Aircraft Industries, a.s.

MANDATORY BULLETIN

MB No. : L13 / 105 a

Concerning: All L13 , L13A BLANÍK gliders

Fig. No. 1

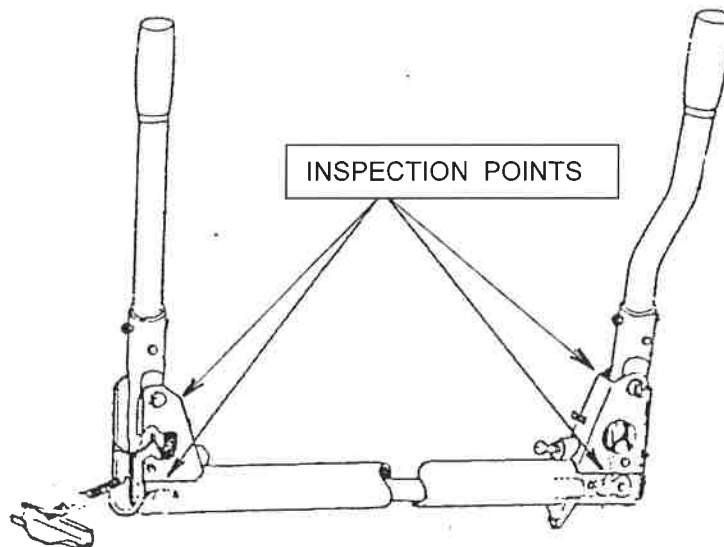
1. Dismantle the covers of both front and rear lever .
2. Inspect visually by means of 6x magnifying magnifier the bedding of front and rear control lever on the control bridge Dwg. No. A401 001N (old Dwg. No. L13.401-Z1) or Dwg. No. A740 370N, according to the specified design of sailplane, at the places around welds and bends (according to Fig.1 on both sides of the bridge) for presence of cracks .
Lighten up inspected places properly. For visually inspection deflect gradually the control lever to the right side endstop (minimum aileron deflection) and still press on the control lever handle to the right with moderate pressure 40 ± 10 N up to the endstop - inspect the relevant part of the bridge, at which springing it causes sharpening of eventual cracks. By the same method carry out inspection at left deflection of control lever. Crack incidence is not allowed .
Carry out checks at designated places of the control bridge at control levers in front and rear cockpit.

5. In a case that some cracks in a bedding have been found, it is necessary to carry out replacement of defected control bridge for a new one according to the Dwg. No. A740 370 N design before continuing operation. For L13 glider there is also installation of original control bridge Dwg. No. A401 001N allowed, provided operator or servicing centre has original Bedding Dwg.No. A741 215N (old Dwg.No. L13.401-25.P1) as unused spare part at disposal.
Carry out replacement according to the Technical and Maintenance Manual of the L13 sailplane / Edition No.4 from the year 1978 or according to the Operational and Maintenance Manual of L13 sailplane - without overhauls or according to the Operational and Maintenance Manual of L13A sailplane, depending on which Manual is actual for given sailplane.
Inform immediately manufacturer about found defect at the same time with handover of sailplane operation data with a view to aerial acrobatics rate.
